Project	IEEE 802.16 Broadband Wireless Access Working Group < http://ieee802.org/16 >
Title	MIB II Integration and MIB II Table
Date Submitted	2006-03-07
Source(s)	Joey Chou [mailto:joey.chou@intel.com] Intel Corporation 5000 W. Chandler Blvd. Chandler, AZ 85226
Re:	
Abstract	This contribution proposed the text for Section 9 of IEEE P802.16i WG draft.
Purpose	Adoption
Notice	This document has been prepared to assist IEEE 802.16. It is offered as a basis for discussion and is not binding on the contributing individual(s) or organization(s). The material in this document is subject to change in form and content after further study. The contributor(s) reserve(s) the right to add, amend or withdraw material contained herein.
Release	The contributor grants a free, irrevocable license to the IEEE to incorporate material contained in this contribution, and any modifications thereof, in the creation of an IEEE Standards publication; to copyright in the IEEE's name any IEEE Standards publication even though it may include portions of this contribution; and at the IEEE's sole discretion to permit others to reproduce in whole or in part the resulting IEEE Standards publication. The contributo

Figure 20= SS/MS DL Synchronization

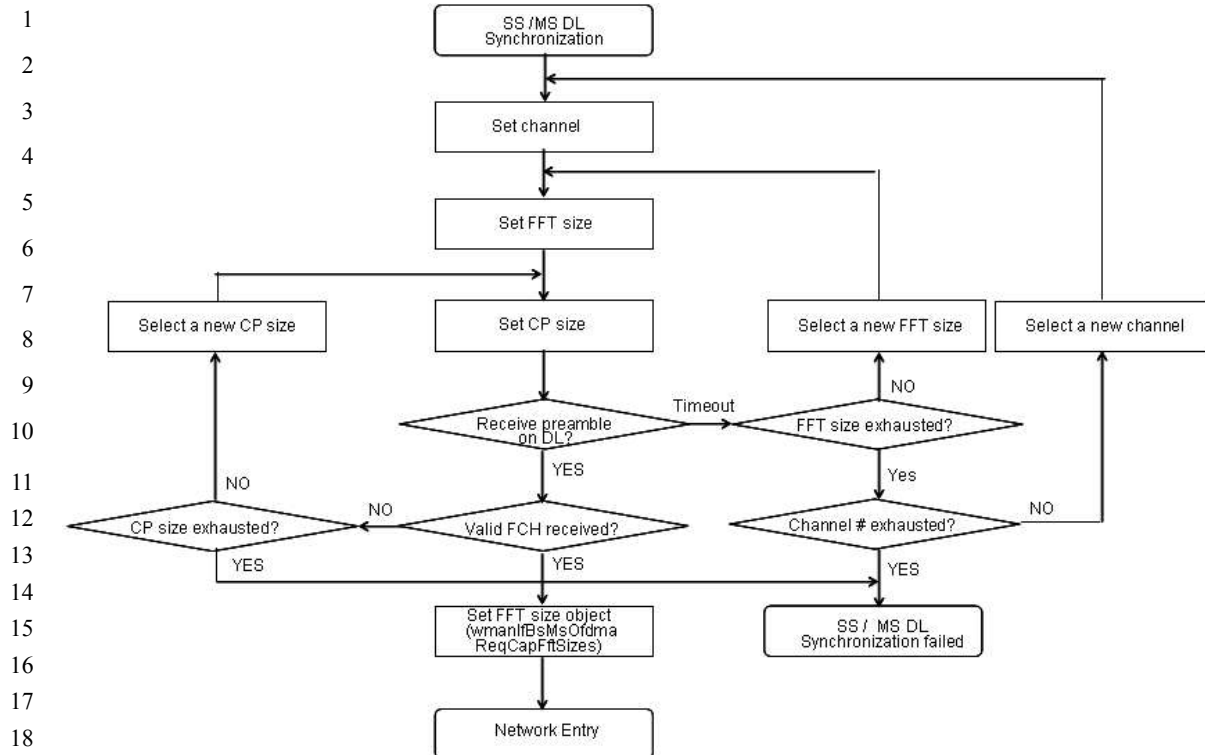
24 Figure 20 shows a procedure describing how BS can determine the FFT size of a SS or MS during
25 the DL synchronization for.

1. Set the Rx channel (Select a frequency for receiving DL channel)
2. Set the FFT size
3. Set the CP size
4. If a preamble is received successfully, then go to step 5; otherwise,
 - 26a. If FFT size is not exhausted, then select a new FFT size, and go to step 2; otherwise,
 - 27. If channel to be scanned is exhausted, then declare SS / MS DL synchronization failed; otherwise, select a new channel, and go step 1
5. Set the CP size
6. If a FCH (Frame Control Header) is received successfully, then go to network entry; otherwise,
 32. a. If CP size is not exhausted, then select a new CP size, and go to step 3; otherwise, declare SS / MS DL synchronization failed
 33. b. Set FFT size object

Figure 21 – SS / MS Network Entry

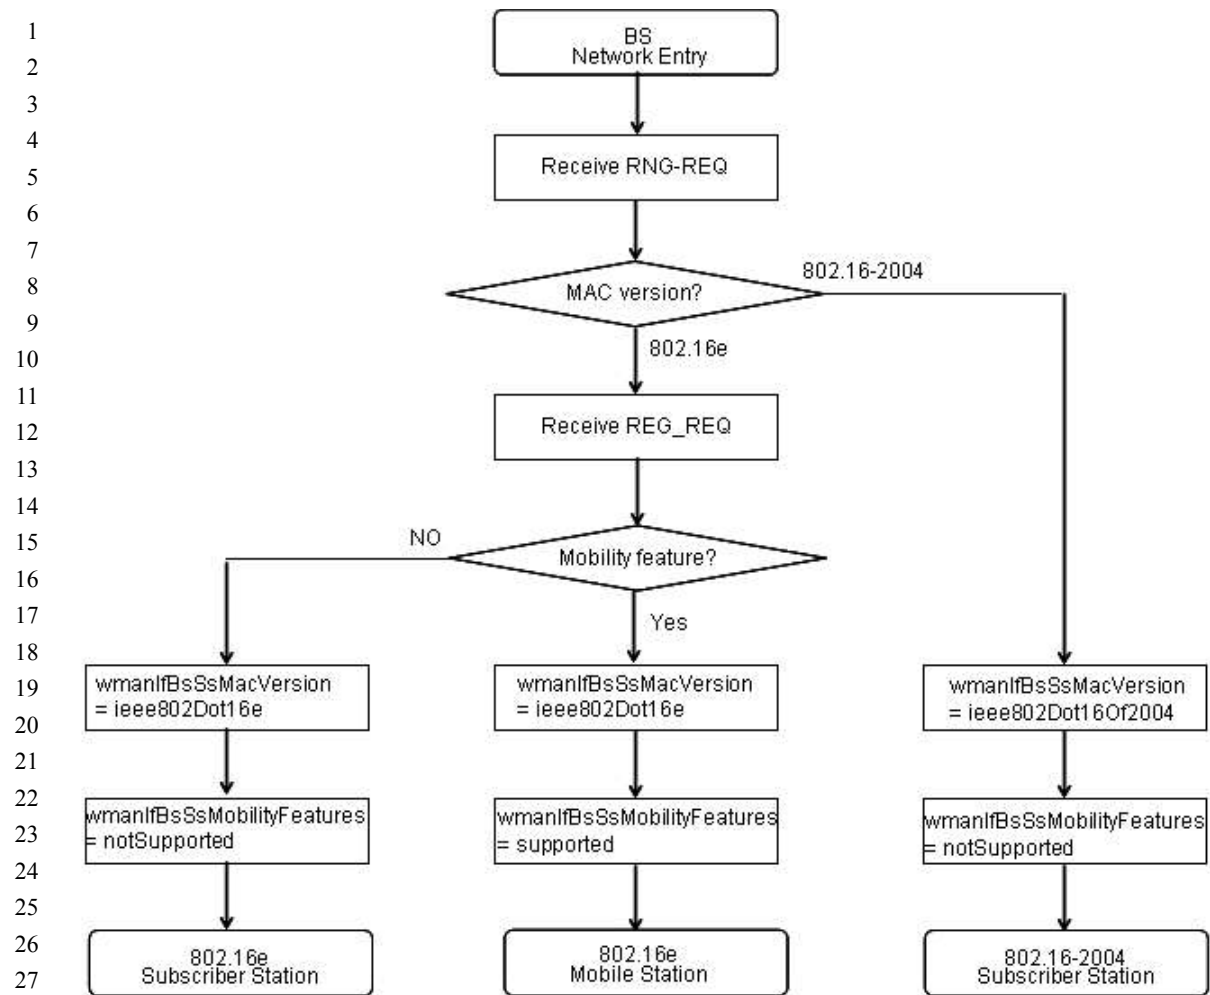
Figure 21 shows a procedure describing how BS can determine the MAC / PHY standard interface and capability a SS / MS can support.

1. Receive RNG-REQ from SS / MS
2. If MAC version is 802.16-2004
 - Then
 - a. wmanIfBsSsMacVersion = ieee802Dot16Of2004
 - b. wmanIfBsSsMobilityFeatures = No Supported
 - c. Go to step 5
3. Receive REG-REQ from SS / MS
4. If Mobility Feature is supported,
 - Then
 - a. wmanIfBsSsMacVersion = ieee802Dot16e
 - b. wmanIfBsSsMobilityFeatures = Supported
 - Otherwise
 - a. wmanIfBsSsMacVersion = ieee802Dot16e
 - b. wmanIfBsSsMobilityFeatures = Not Supported
5. Continue network entry procedure
